J2126A-05

S E R V I C E N O T E

AGILENT J2126A Transmission Test Set

Small cracks on the front and back castings.

Figure 1 Location of J2126A Tie Bars and Spacers

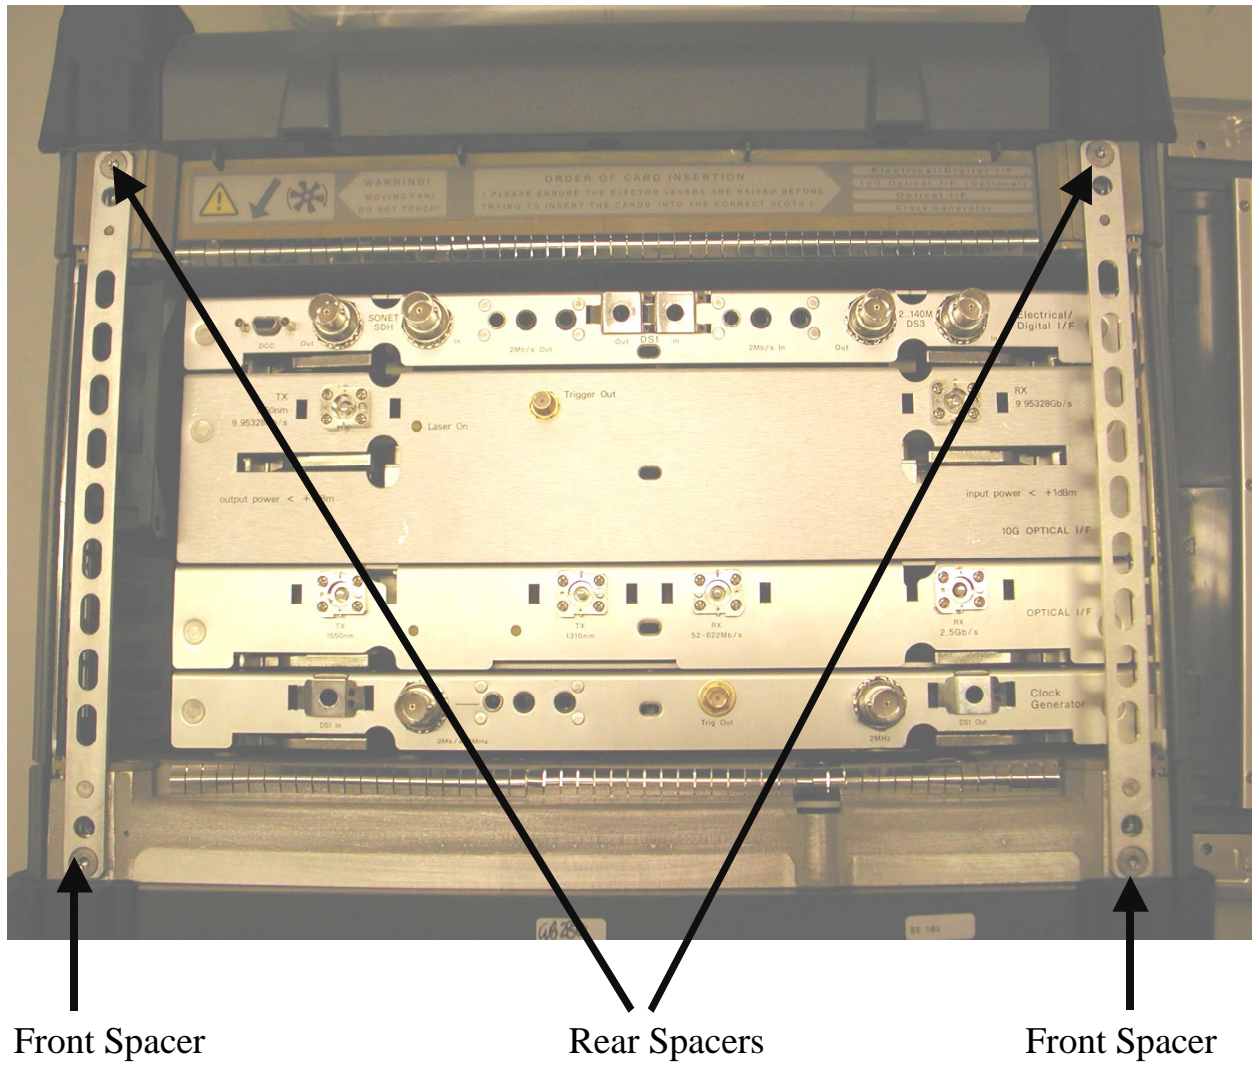
A failure may occur on the front or back castings due to some small cracks appearing around the screw holes at the corner of the castings. The cracks are caused if excess torque is used when screwing the tie bars to the castings. (The tie bars hold the front and back castings rigid.)

Spacers should be fitted between the tie bar and the castings.

1. Unscrew the torque #15 screws at each corner of the top panel.
2. Remove the top panel.
3. Locate the tie bars at either side of the instrument. Check the front and back of each tie bar to see if spacers have been fitted between the tie bars and the castings. See Figure 1.
4. If no, continue with step 6; if yes, go to step 8.
5. Unscrew the torque #15 countersink screws which fix the tie bars to the front and back castings.
6. Lift both tie bars and fit a spacer at the front (J1413-00052) and back (J1413-00053) of each casting, between the tie bar and the casting.
7. Replace the torque #15 countersink screws which fix each tie bar to the front and back castings.
8. Replace the top panel. Care must be taken to align the top panel with the connectors on the plug-in modules.
9. Replace the torque #15 screws to secure the top panel.
